PLANNING & ZONING COMMISSION

AUGUST 14, 2023, 7:00 PM

PLANNING & ZONING COMMISSION REGULAR MEETING

Halff Associates, Inc. was requested by the City of Sanger to review the drainage study in support of the engineering plans for the Bentley Addition located near the intersection of FM 2450 and FM 455 W. The subject tract is located within the City of Sanger's ETJ. The submittal was prepared by Triangle Engineering LLC and dated June 21, 2023.

<h1 style="margin: 0;">GRADING PLAN</h1> <h2 style="margin: 0;">DOLLAR GENERAL</h2>							
<p>NE QUADRANT OF FM 2450 & CHAPMAN ROAD</p> <p>CITY OF SANGER ETJ</p> <p>DENTON COUNTY, TEXAS 76266</p>							
<p>JAMES B.P. JANUARY SURVEY ABSTRACT NO # 658</p>

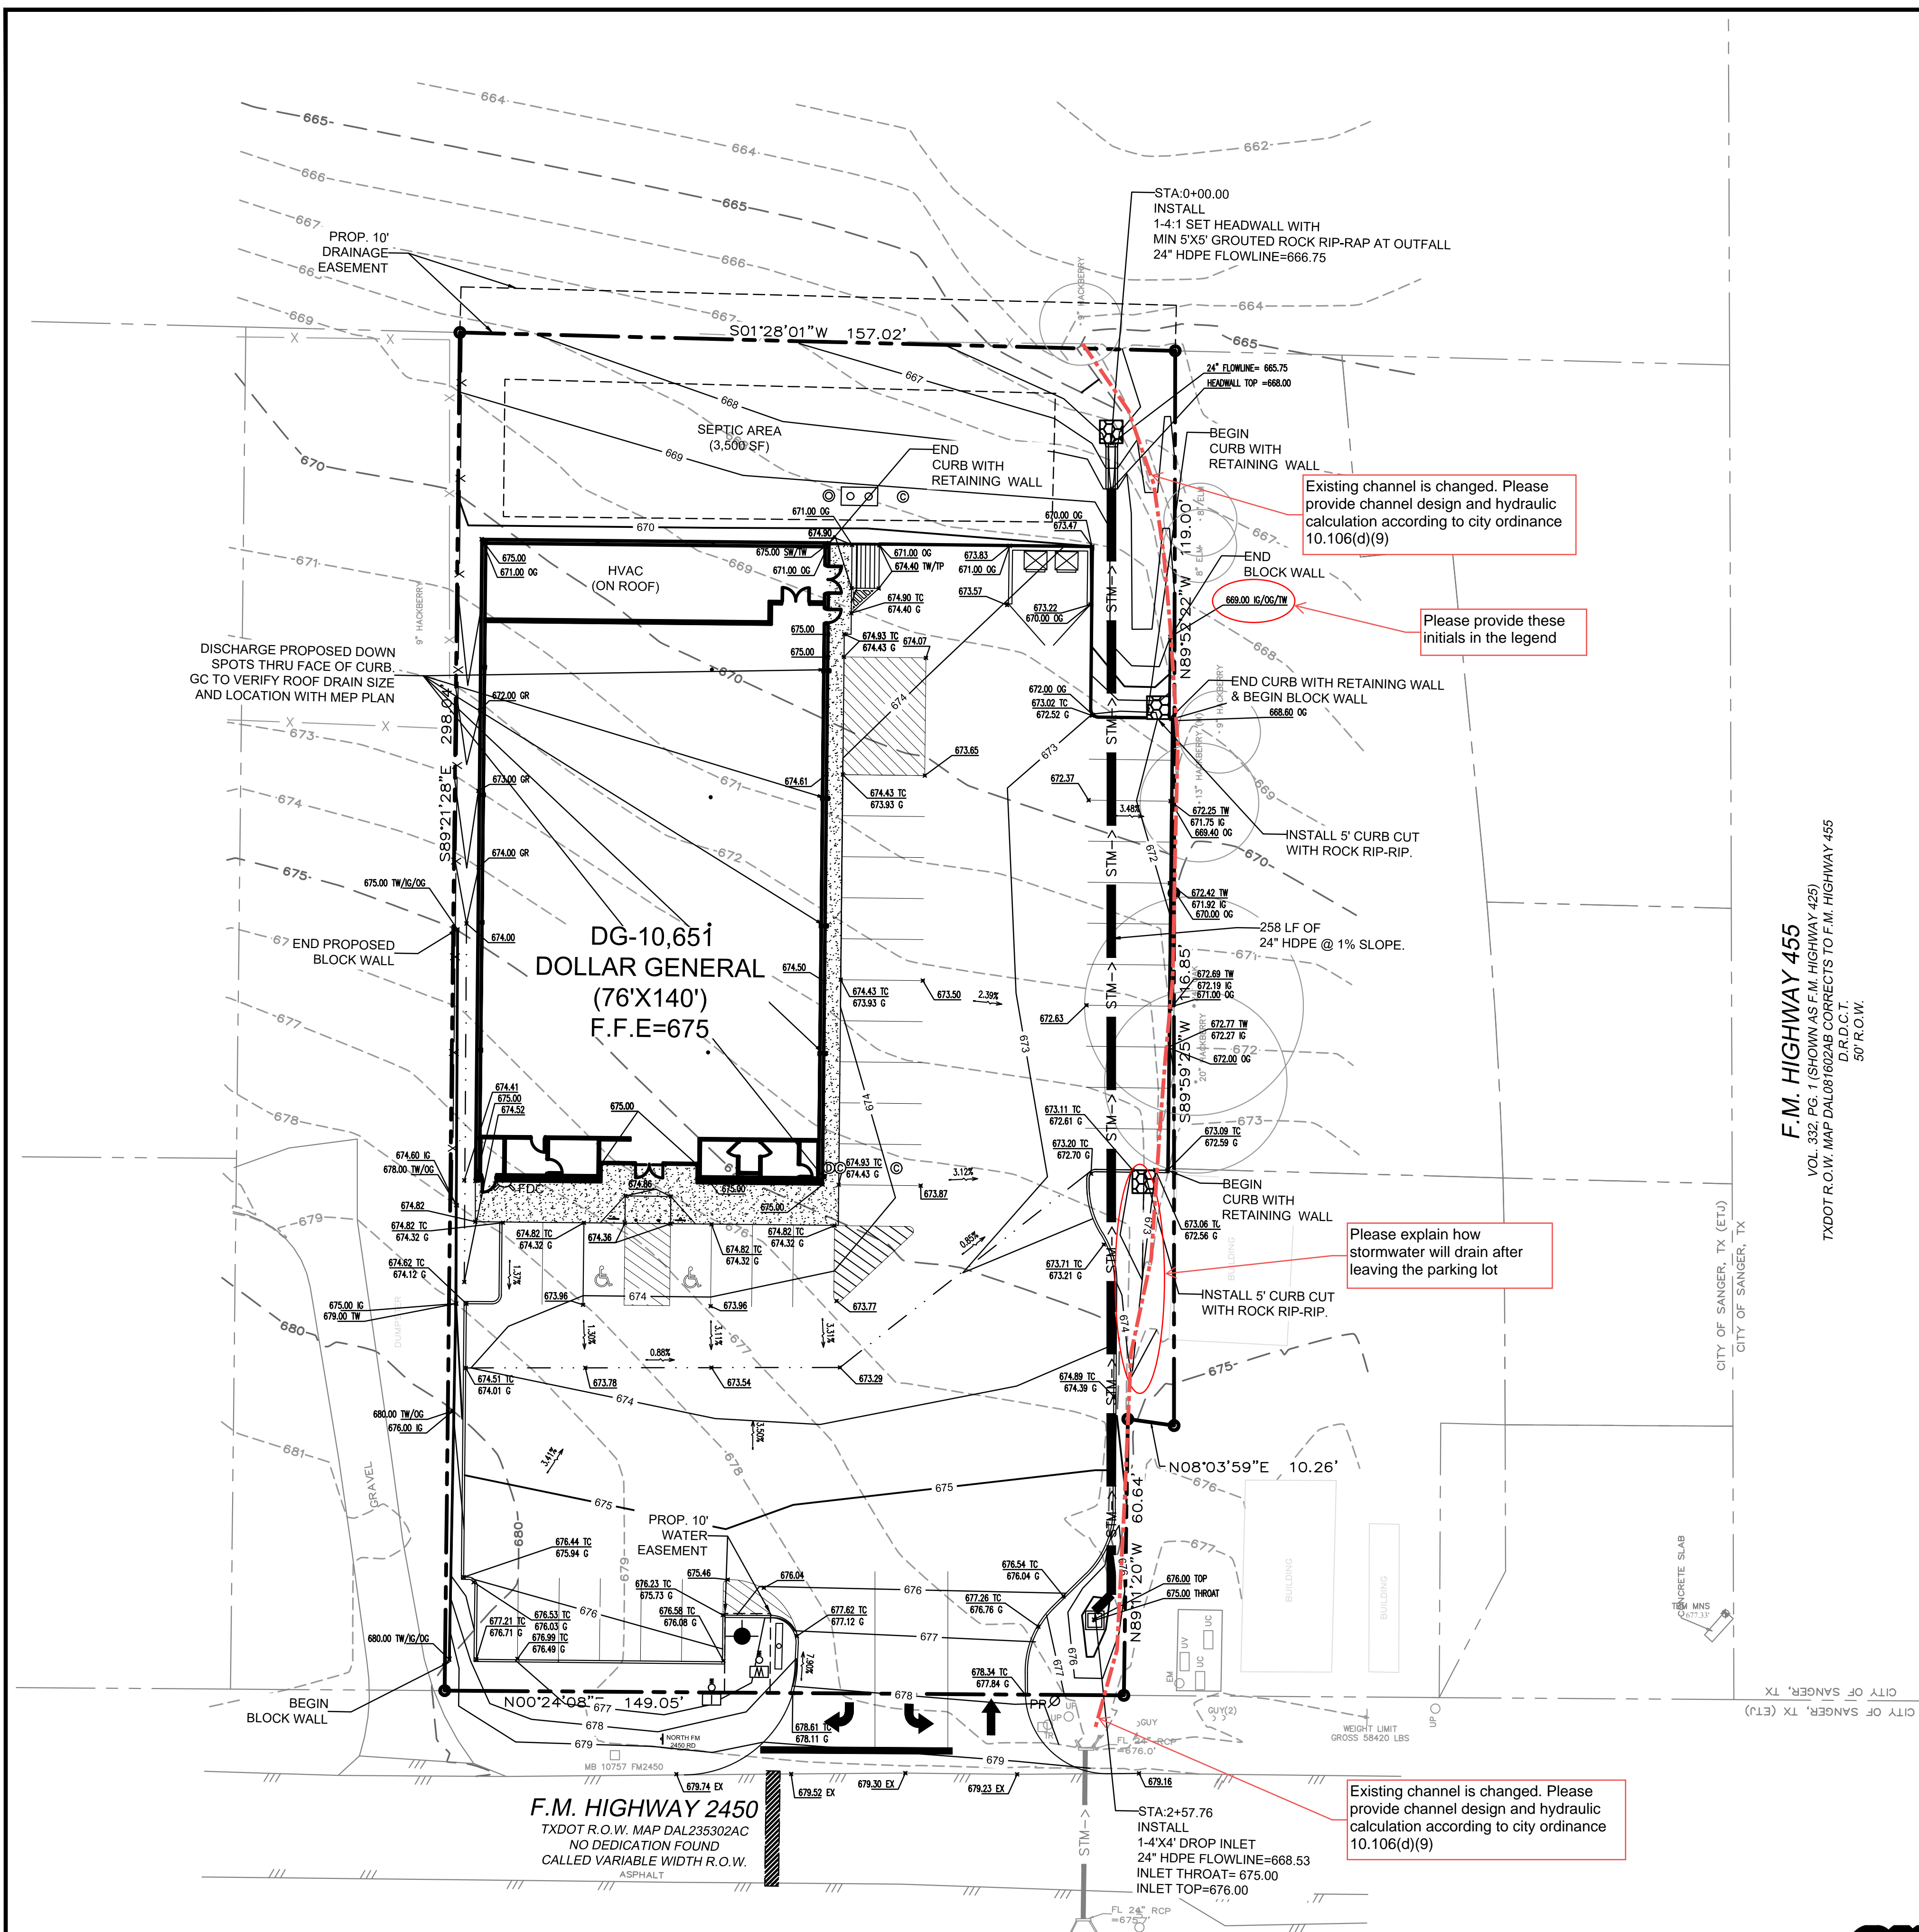
Existing channel is changed. Please provide channel design and hydraulic calculation according to city ordinance 10.106(d)(9)

Please provide these initials in the legend

Please explain how stormwater will drain after leaving the parking lot

DRAINAGE AREA MAP

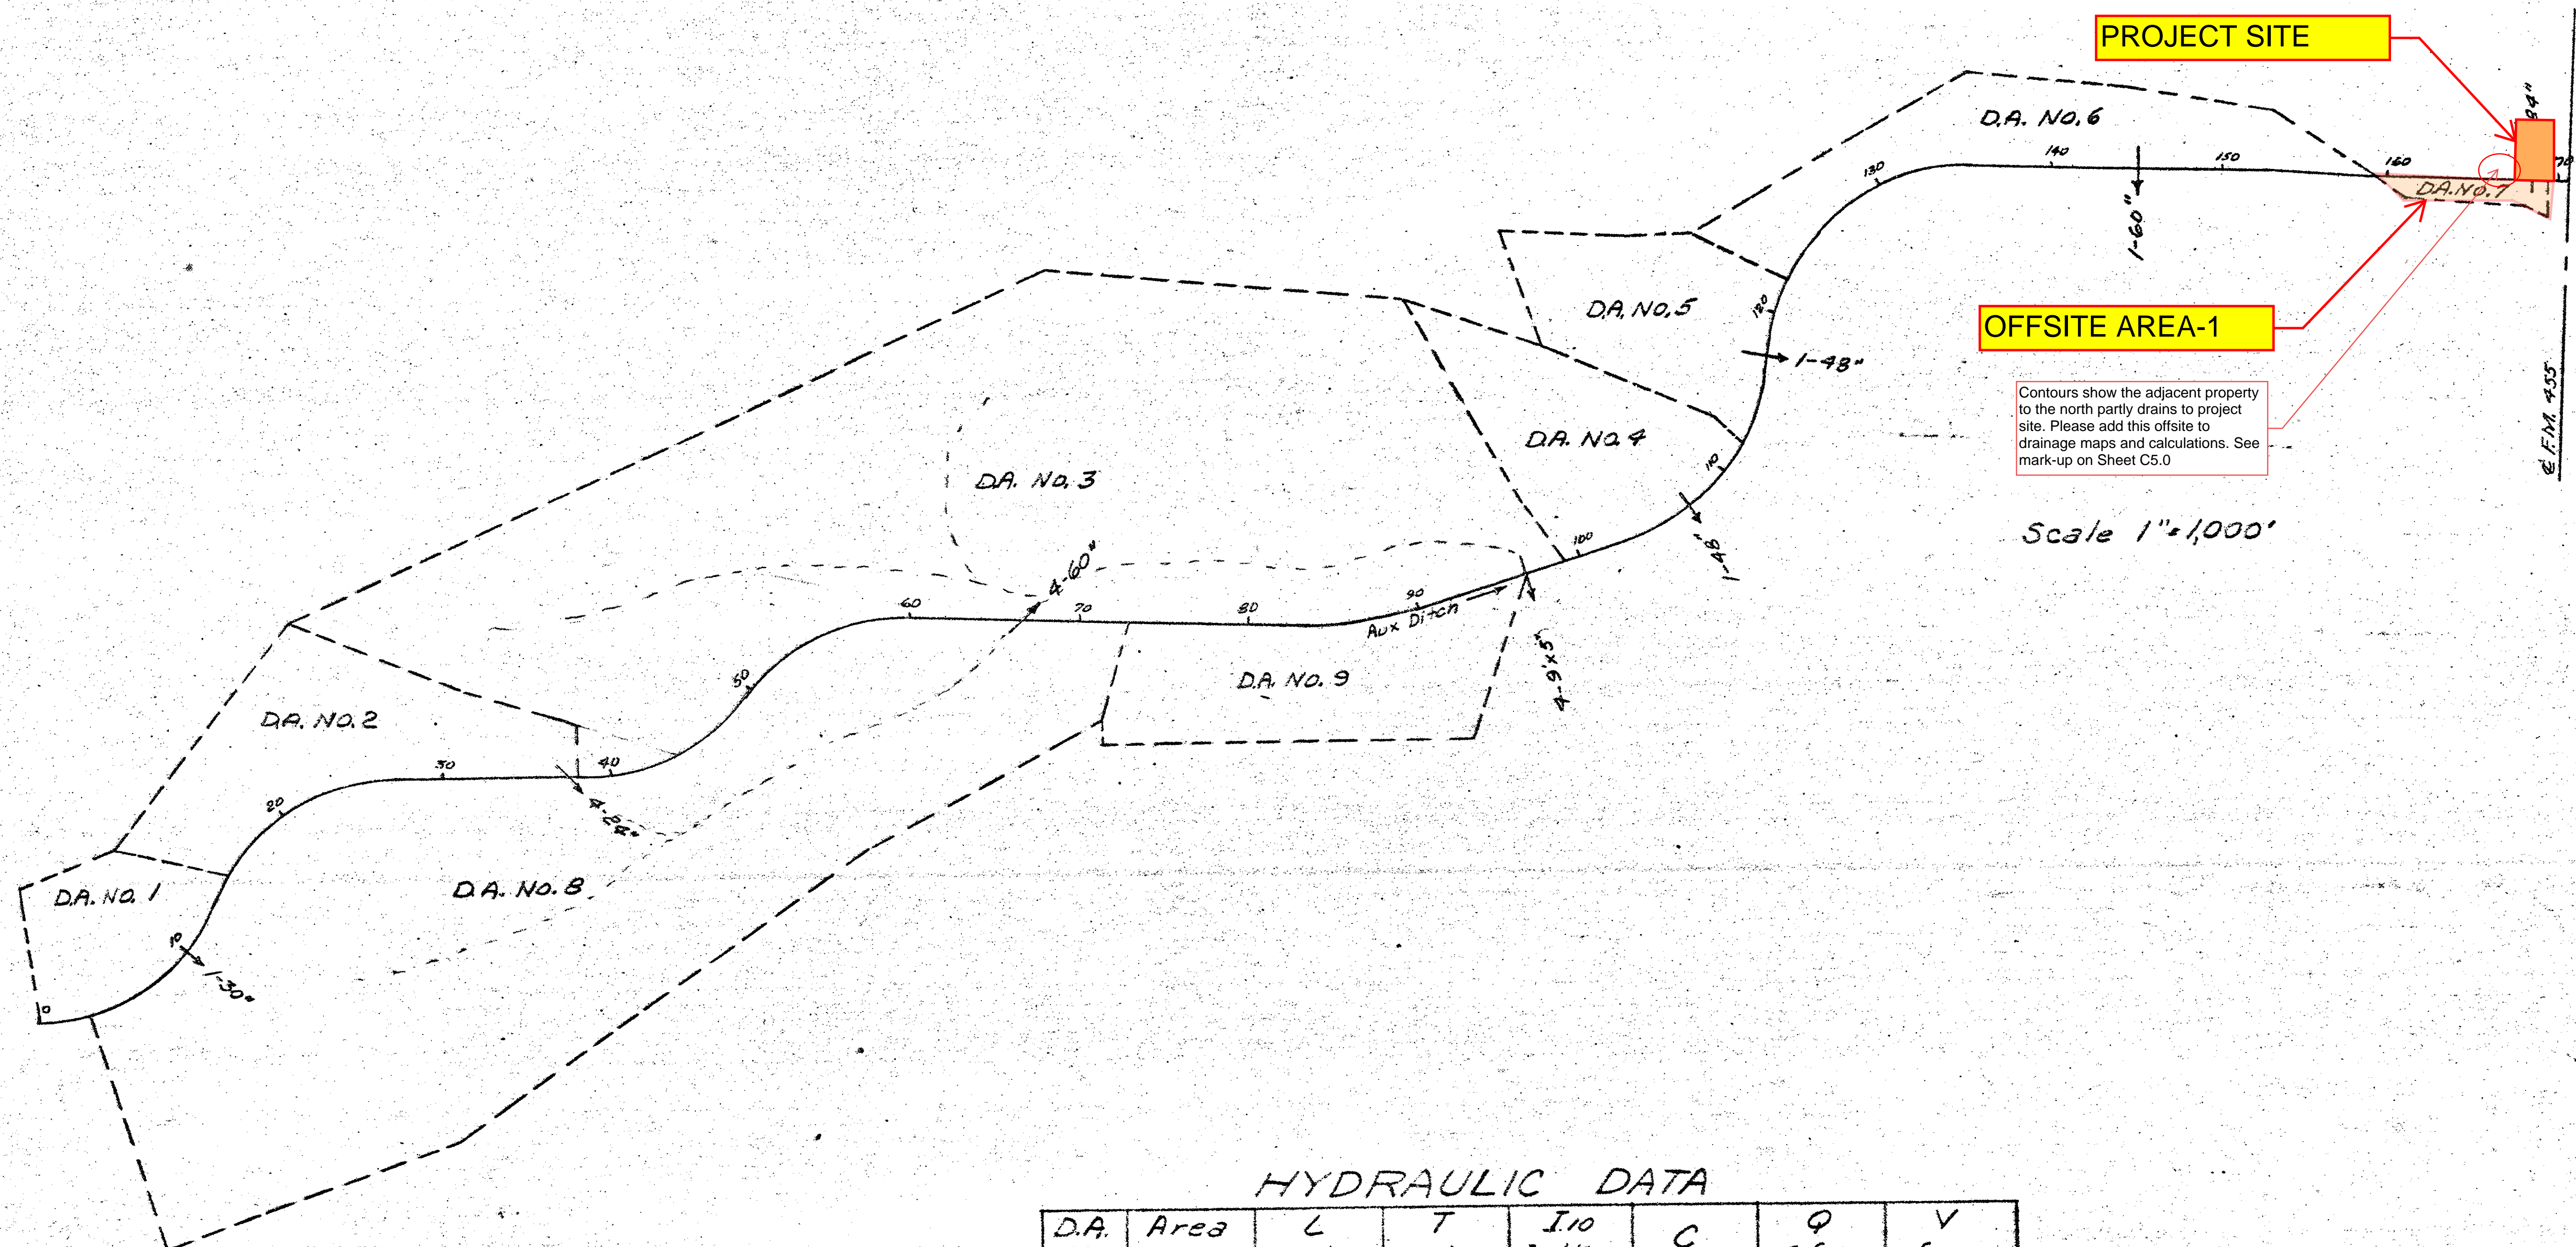
5. The Drainage Area Maps (between Sheet C-4.0 and C-5.0) were for FM Hwy 2450 hydraulic calculation's purpose. Please include extra offsite drainage area per mark-ups on Sheet C-5.0.

Existing channel is changed. Please provide channel design and hydraulic calculation according to city ordinance 10.106(d)(9)
